ADDENDUM NO. 1

SUBJECT: Addendum No. 1 – 600 Block of Market Street Project

PROJECT NO.: 17A-R-0625

PROJECT No.	YEAR	SHEET No.	
17A-R-0625	2018	9A	
REVISIONS			
No.	DATE	BY	BRIEF DESCRIPTION
1	8/30/18	RB	Revised One Line Diagrams & Note 4

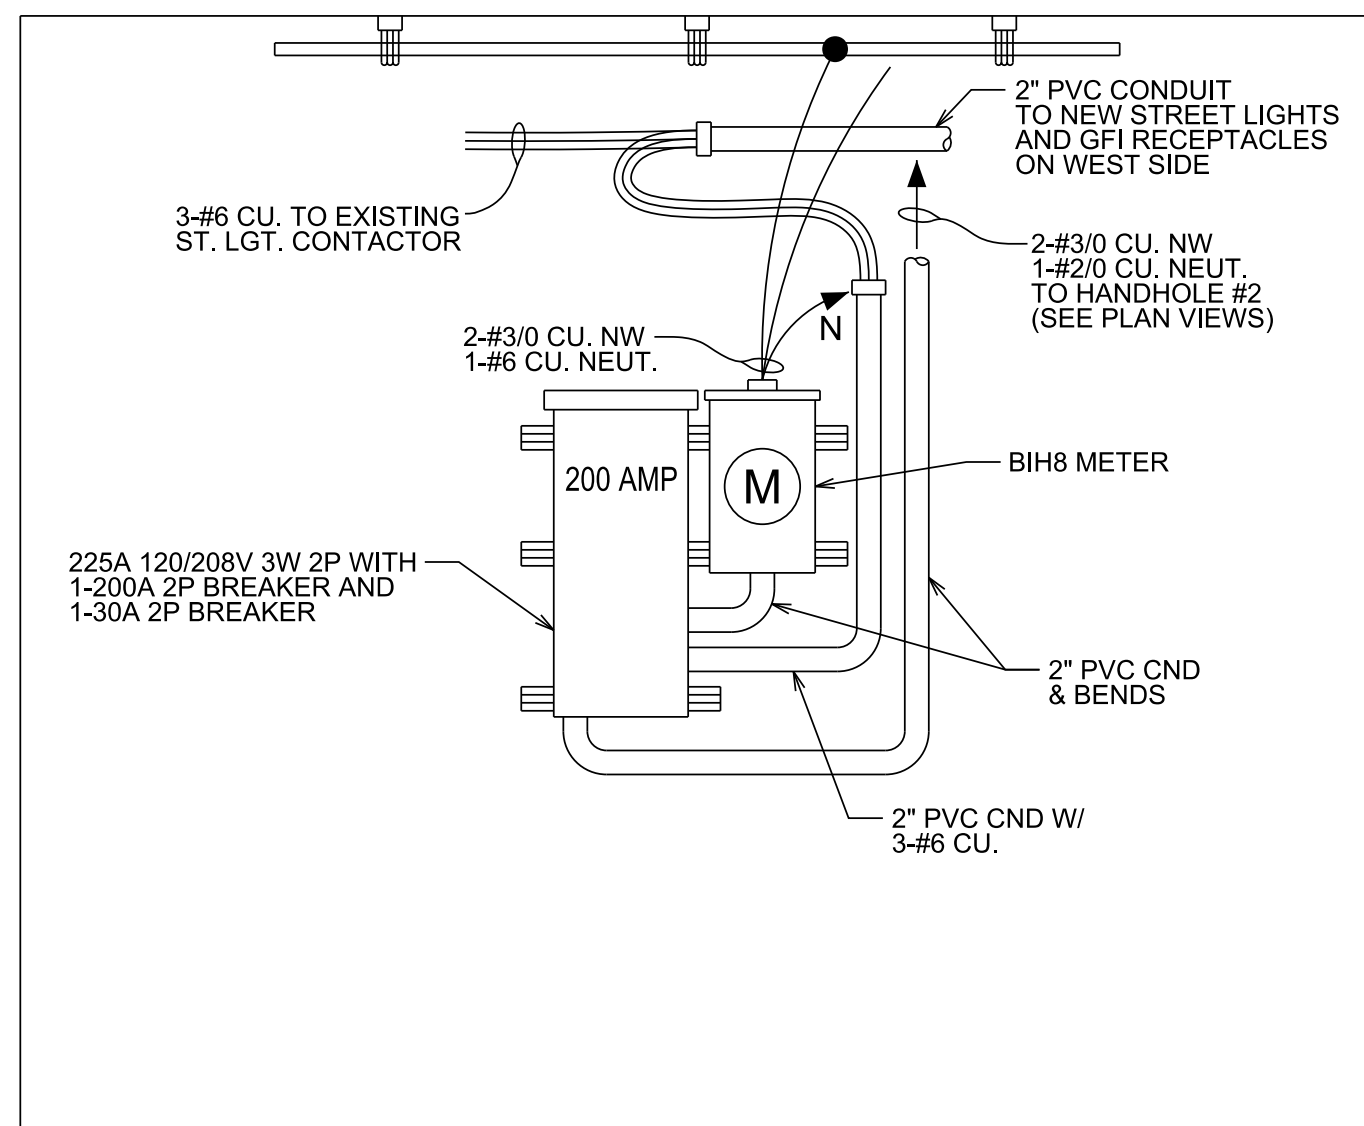
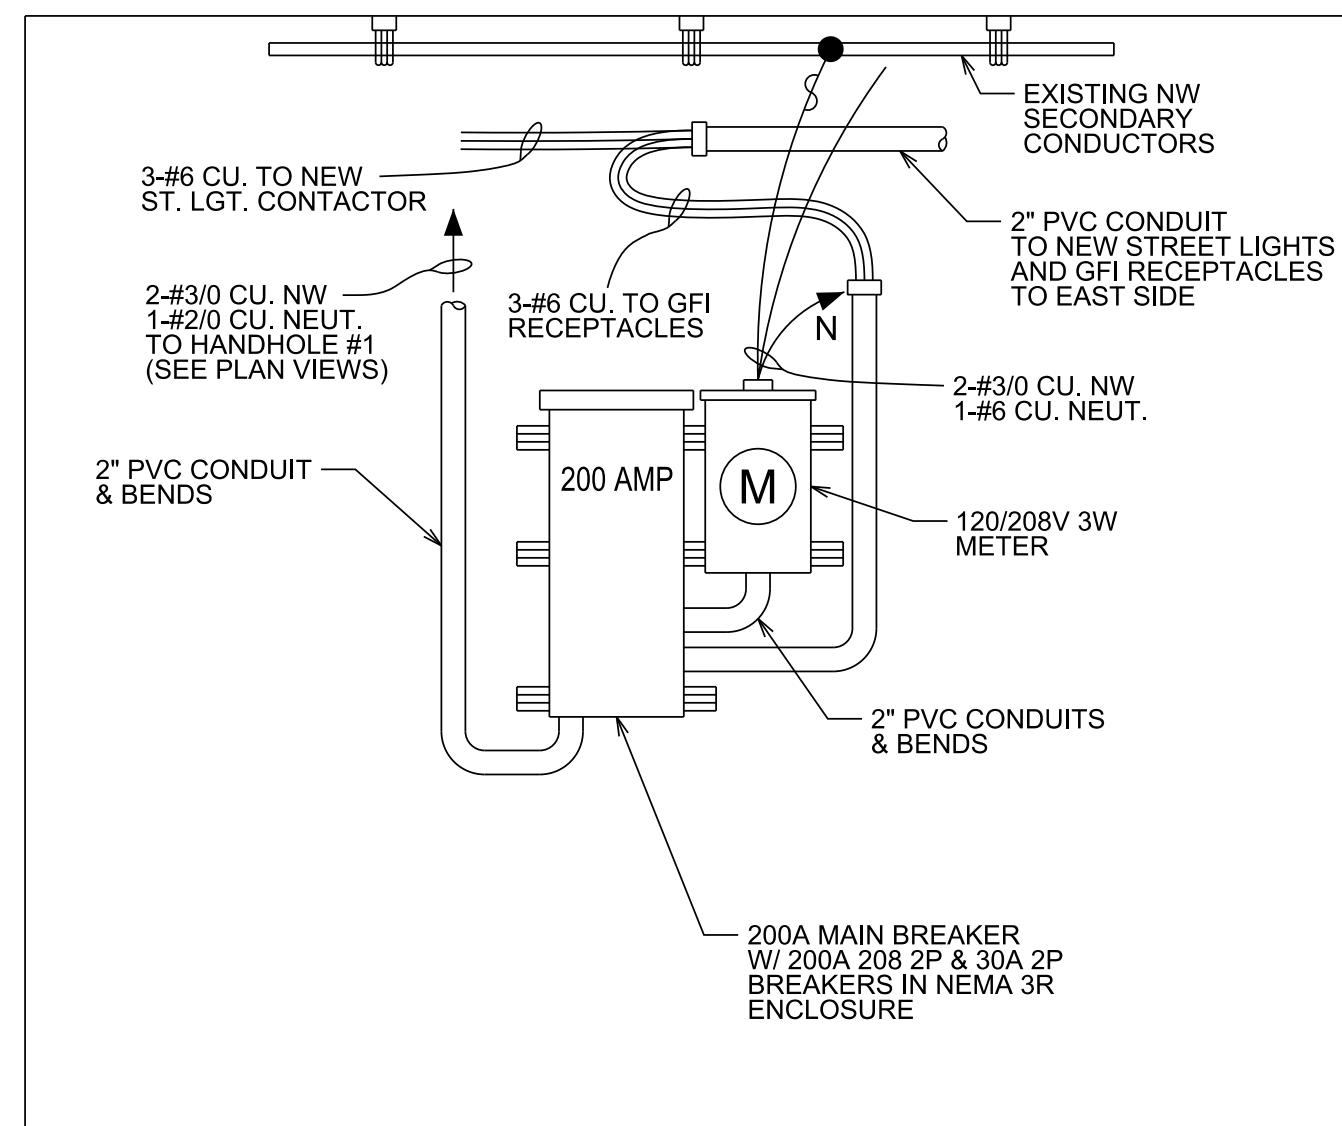
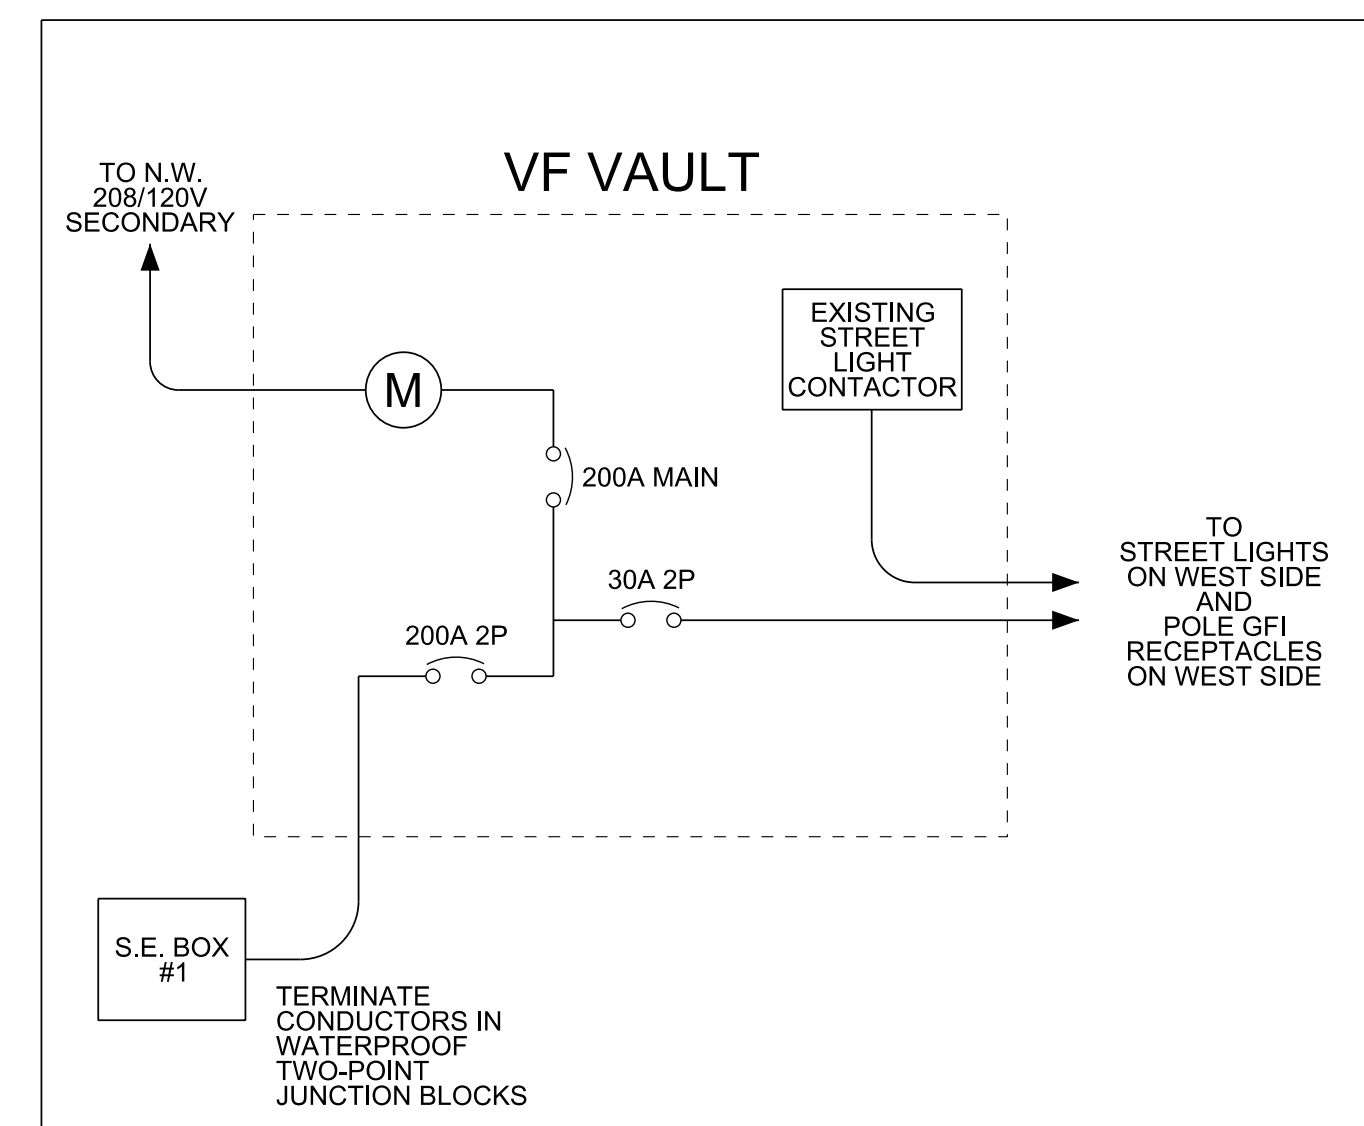
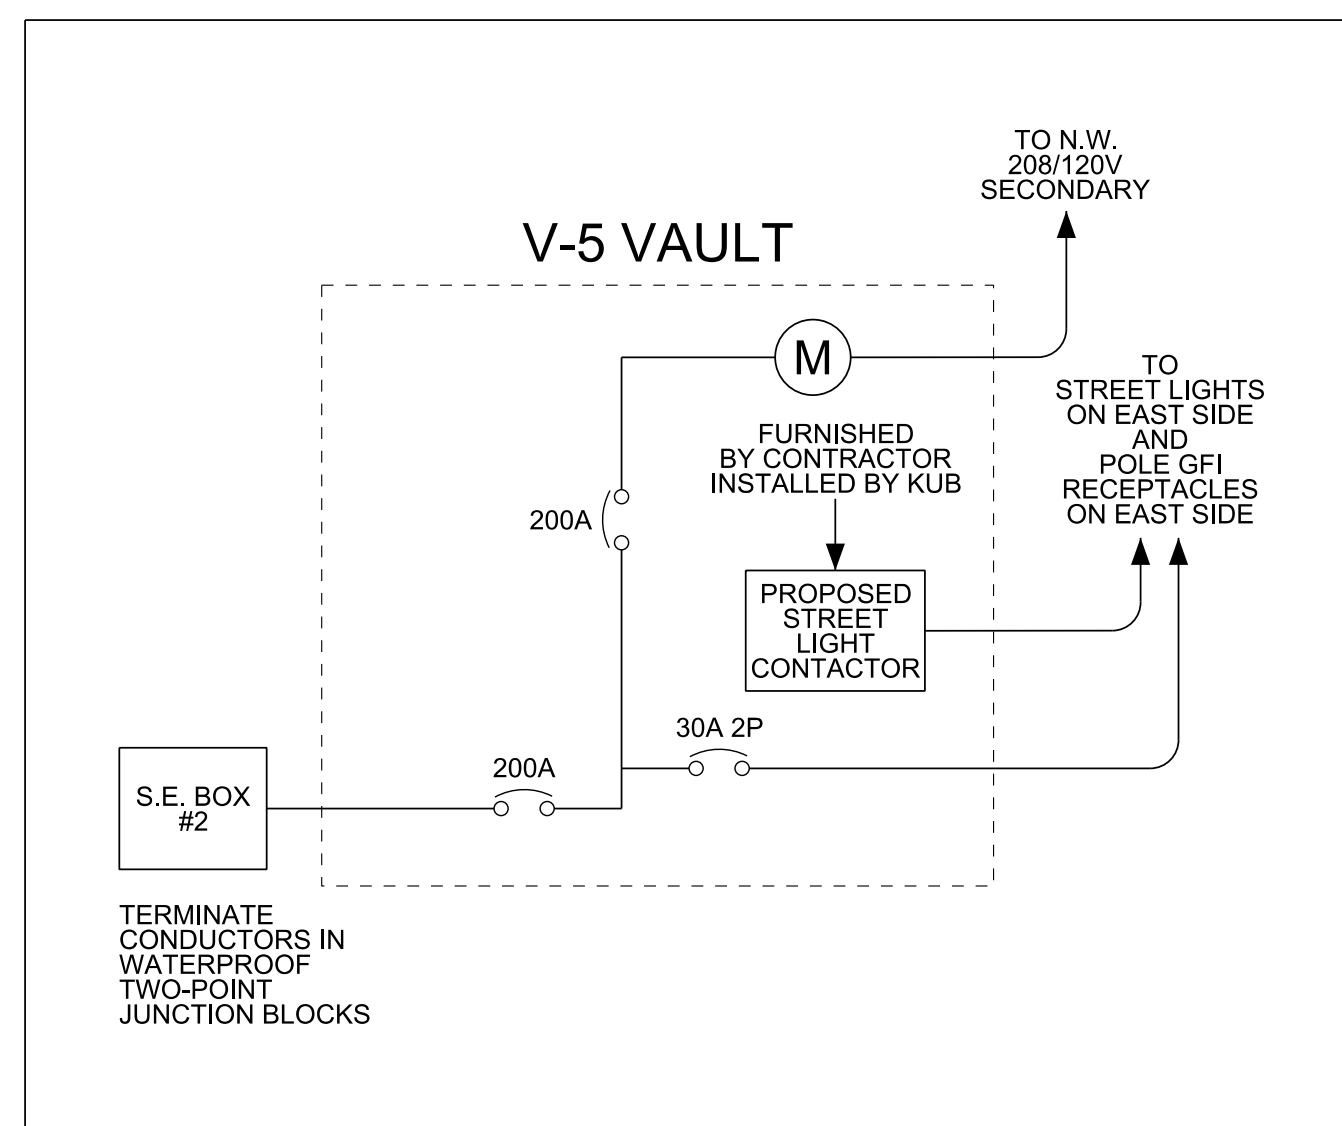
- 1.) Sheet 2 – Revised pay items and quantities.
- 2.) Sheet 5 – Added note for utility vault to be removed.
- 3.) Sheet 6 – Added approximate basement locations.
- 4.) Sheet 9 – Revised electrical design and quantities.
- 5.) Sheet 9A – Revised one line diagrams and Note 4.
- 6.) Sheet 9B – Removed reference to KUB in detail notes.

Bank Of Knoxville - Snow Melting system for sidewalk

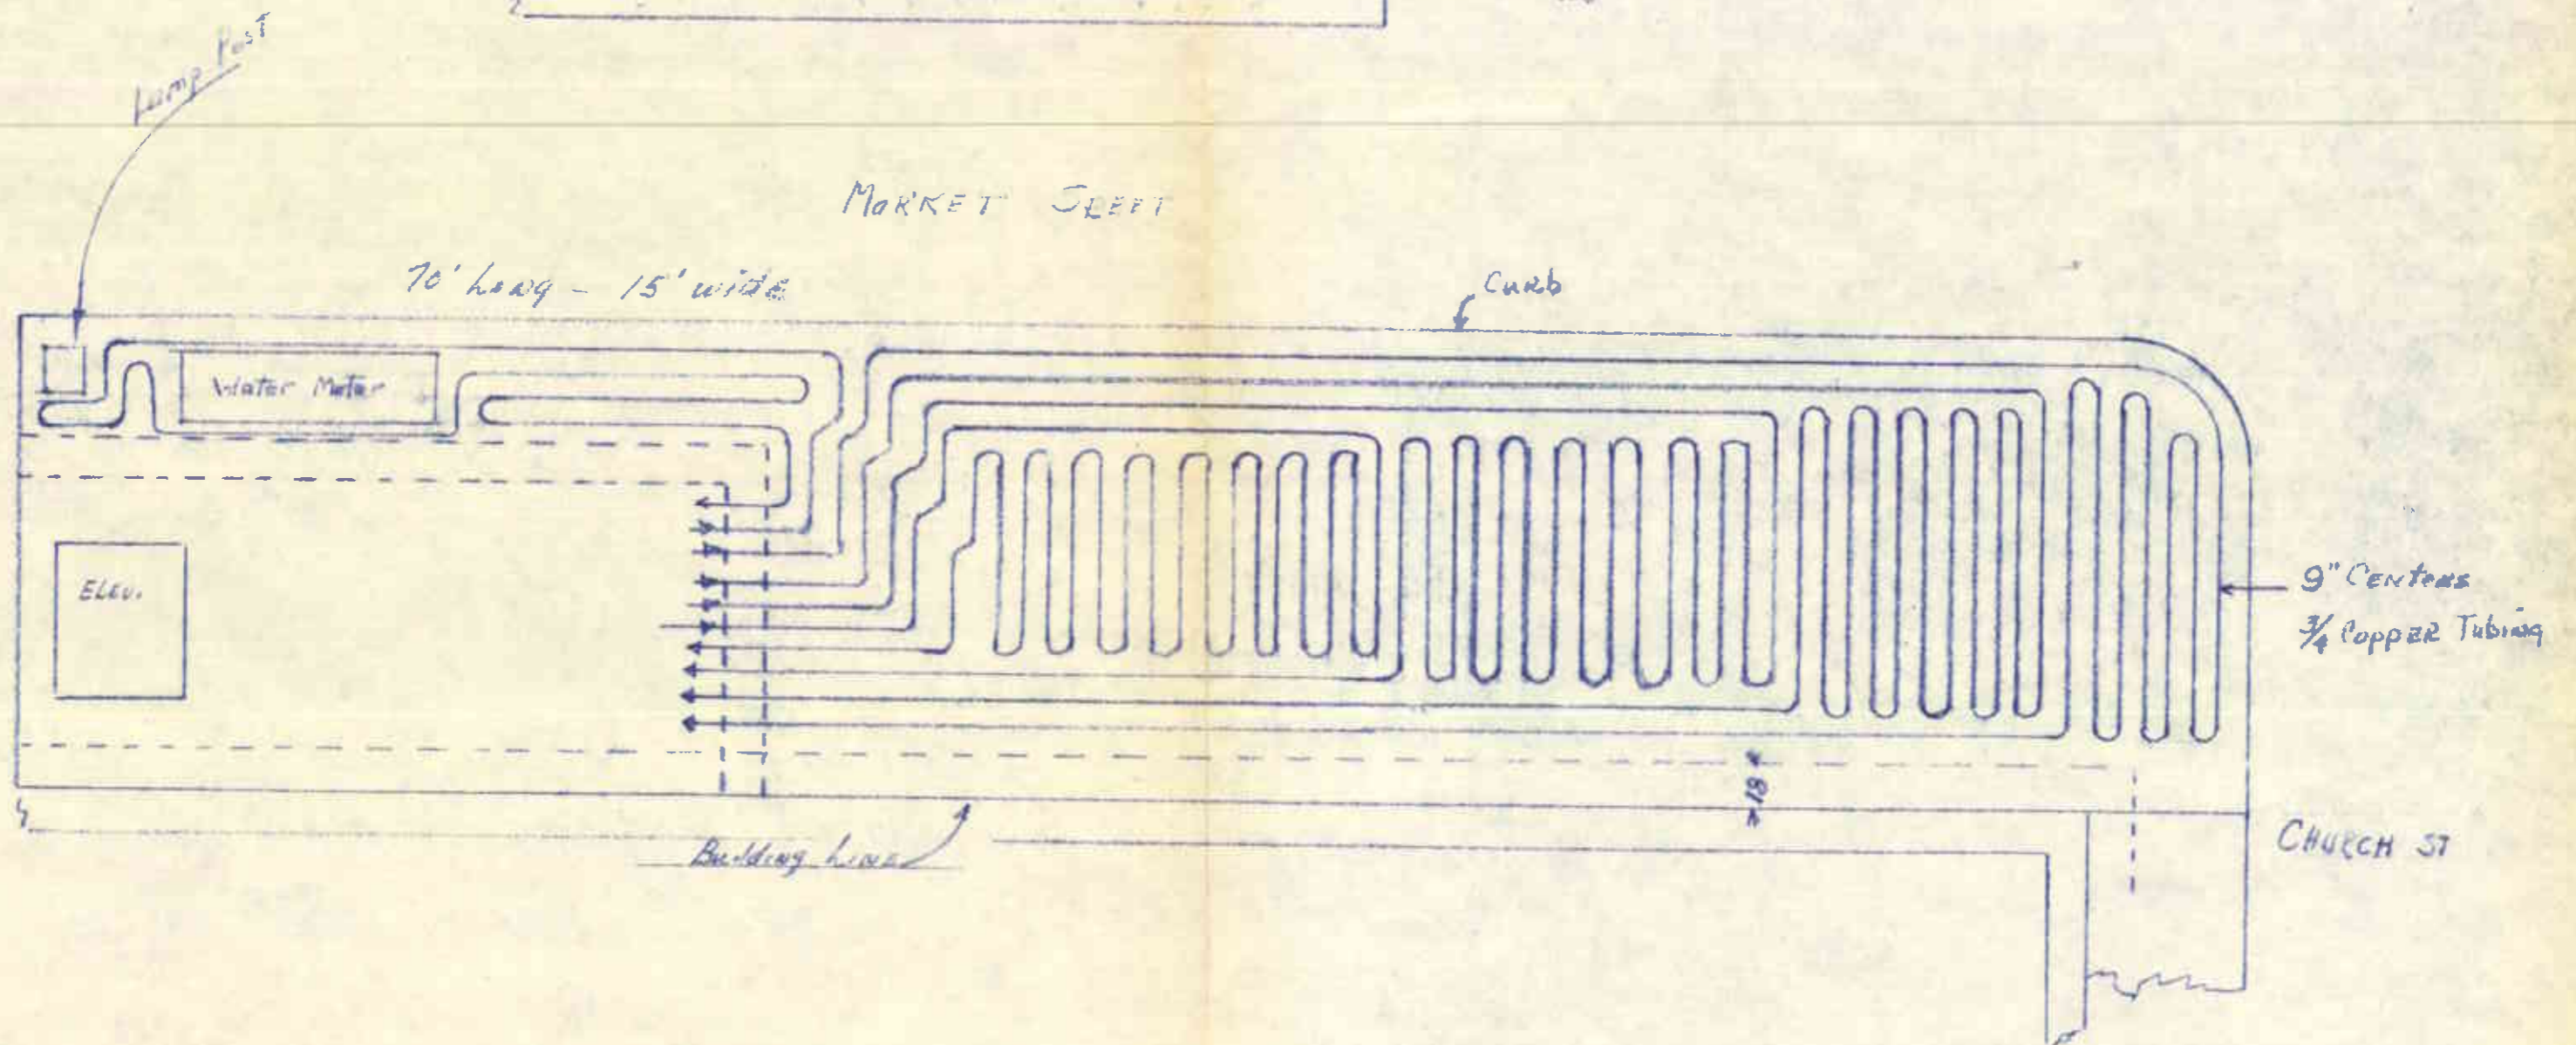
It has been discovered that there is an old heating system installed under the brick sidewalk in front of the Trotter Building at 625 Market Street. Discussions with the building maintenance manager indicate that the system is no longer operational. It is not anticipated that the system will be disturbed as part of the proposed sidewalk construction. However, a letter and diagram from January 5, 1968 is included with this addendum for informational purposes.
